# Access Compliance Report

## Public Rights-of-Way

### (Curb Ramps)

Intersection ID: 12618	Main Street: E_5TH_ST	Cross Street: N_CALDWELL_ST	Location: E
ADA ID: 4012CB94A1A1	Ramp Type: Perp	Initial Pass/Fail: Fail	Overall Compliance: No
Severity Score: 21.25			
Codes/Mitigation Info/Possible Solution		Field Measurements/Component Compliance

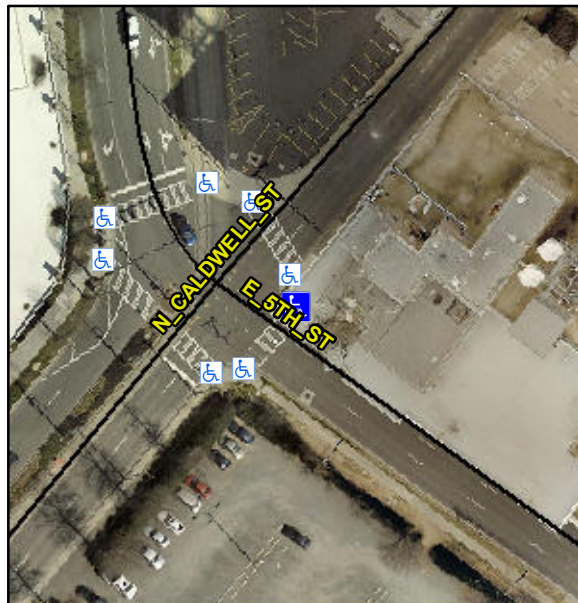
**Not Found, R304.5.1, R304.5.3**

Compliance	Description	Data	Compliance	Description	Data
N/A	Ramp Length (in)	53.0	Yes	Ramp Slope (%)	5.4
No	Ramp Width (in)	47.0	No	Ramp XSlope (%)	5.2
N/A	Flare Type LT	N/A	N/A	Flare Type RT	N/A
N/A	Flare Slope LT (%)	N/A	N/A	Flare Slope RT (%)	N/A
N/A	Flare Traversable LT?	N/A	N/A	Flare Traversable RT?	N/A
N/A	Landing Length (in)	N/A	N/A	DWS Provided?	N/A
N/A	Landing Width (in)	N/A	N/A	DWS Contrast?	N/A
N/A	Landing Slope (%)	N/A	N/A	DWS Length (in)	N/A
N/A	Landing X Slope (%)	N/A	N/A	DWS Full Width?	N/A
N/A	Landing Curb? (Y/N)	N/A	N/A	DWS Offset (in)	N/A
N/A	Shared Landing?	N/A			
N/A	Gutter Ponding?	N/A	N/A	Gutter Slope (%)	N/A
N/A	Gutter Lip Ht (in)	N/A	N/A	Gutter X Slope (%)	N/A
N/A	Painted X Walk1?	Yes	N/A	Painted X Walk2?	N/A
	X Walk 1 Direction	To SW		X Walk 2 Direction	N/A
N/A	X Walk 1 Width (in)	105.0	N/A	X Walk 2 Width (in)	N/A
	X Walk 1 Slope (%)	1.8		X Walk 2 Slope (%)	N/A
	X Walk 1 X Slope (%)	3.5		X Walk 2 X Slope (%)	N/A

**Remove & Replace Entire Ramp.**
